AGENDA

CITY PLANNING COMMISSION

City Hall - Council Chambers
6131 Taylorsville Road
October 26, 2021
6:00 P.M.

SHEET NUMBER		C2.0	
KHA PROJECT NO.		170096004	
ORIGINAL ISSUE:		10/1/2021	
UNION AT CHAMBERSBURG BASIC DEVELOPMENT PLANS		EXISTING CONDITIONS PLAN

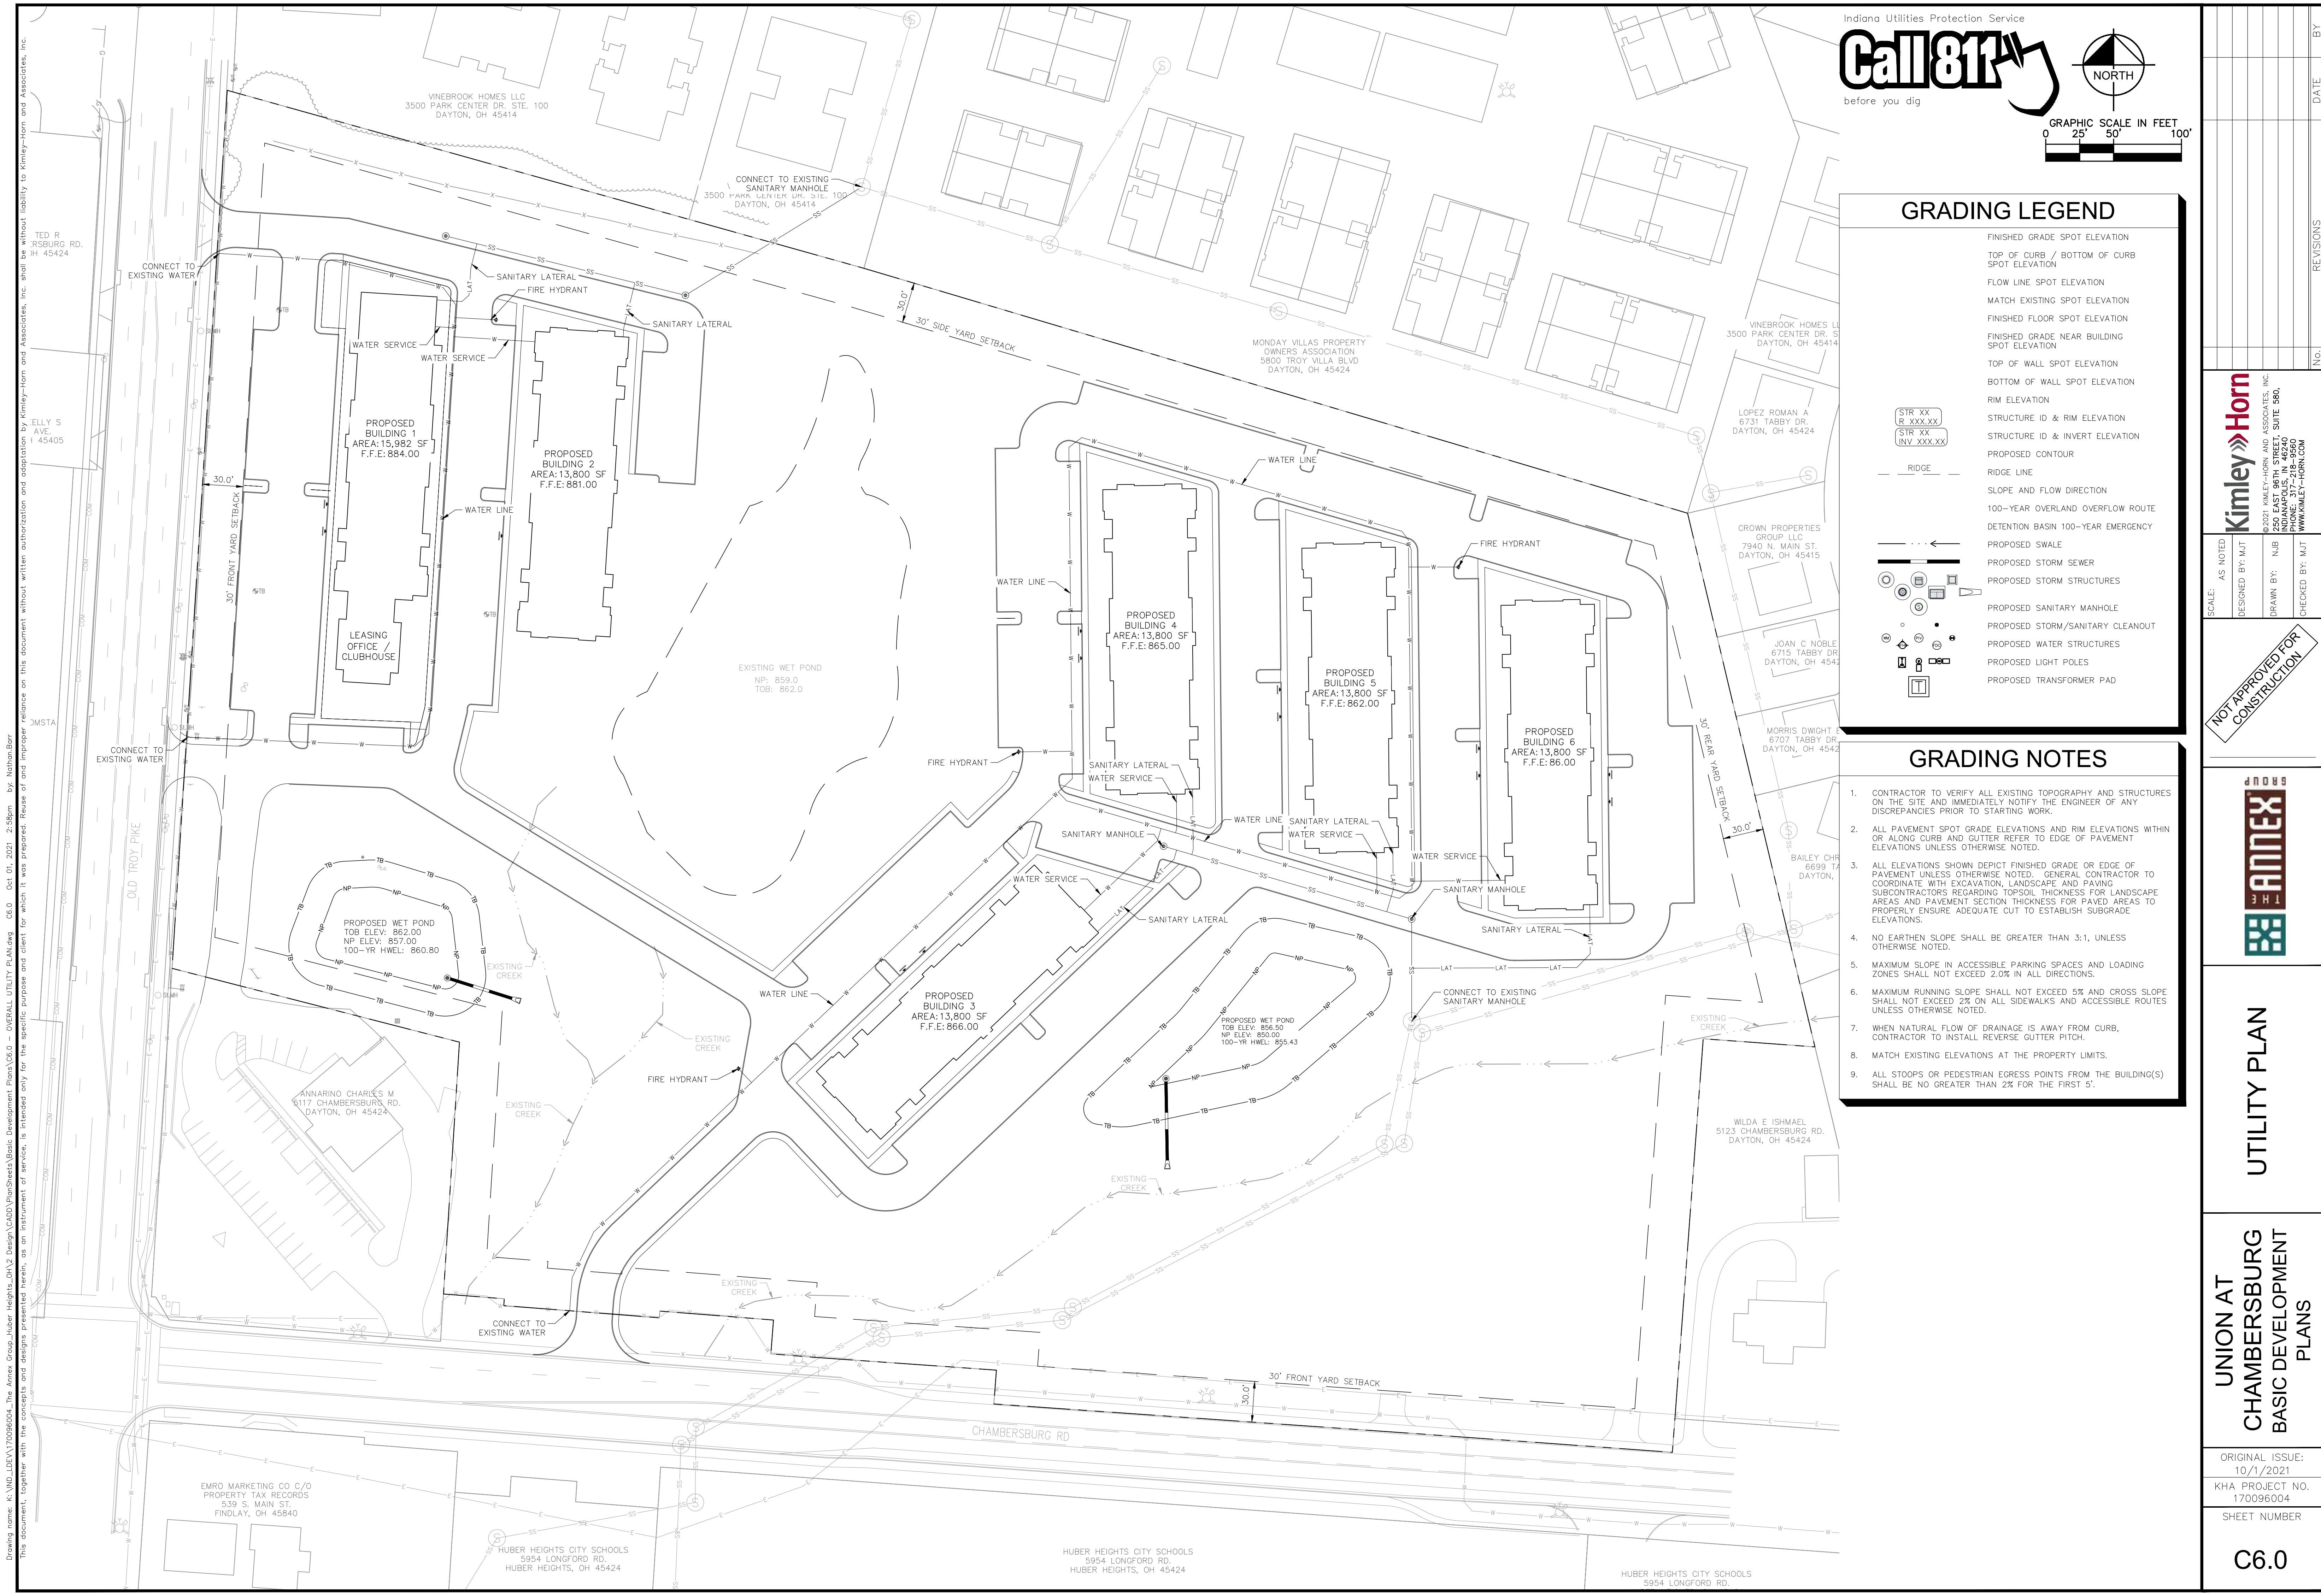
- Additional access is required to the residential portion of project. Refer to OFC 503.1.2 and Appendix D106.1. **Corrected. Proposed drawing C3.0, dated 10/1/2021, shows access entries on Chambersburg Road and Old Troy Pike.**

- Buildings where the vertical distance between the grade plane and the highest roof surface exceeds 30 feet, shall be provided with approved aerial fire apparatus access roads. OFC Appendix D105.1. Refer to D105.2, D105.3 and D105.4 for additional requirements. **Aerial access for buildings 1,4 and 5 meets the requirements of D105 due to no parking along back sides. Aerial access for buildings 2,3 and 6 slightly exceeds the maximum**

- Multi family residential developments with more than 200 dwelling units shall have two separate and approved fire access roads regardless of whether they are equipped with an approved automatic sprinkler system. OFC Appendix D106.2. **Proposed drawing C3.0, dated 10/1/2021, shows access entries on Chambersburg Road and Old Troy Pike.**

- The minimum drive width shall be 26 feet with fire hydrants. OFC Appendix D103.1. **Proposed drawing C3.0, dated 10/1/2021, shows roads to be 26 feet in width.**

- The turning radius for fire department access roads shall meet requirements for Huber Heights Fire Division (HHFD) vehicles. Contact HHFD to obtain information. OFC 503.2.4 and Appendix D103.3. **Turn radius shown on proposed drawing C3.0, dated 10/1/2021 appears to comply.**

- Fire department access roads shall not have dead ends over 150 feet without an approved turnaround. OFC 503.2.5 and Appendix D103.4. **Dead ends over 150 feet have been removed as shown on proposed drawing C3.0, dated 10/1/2021.**
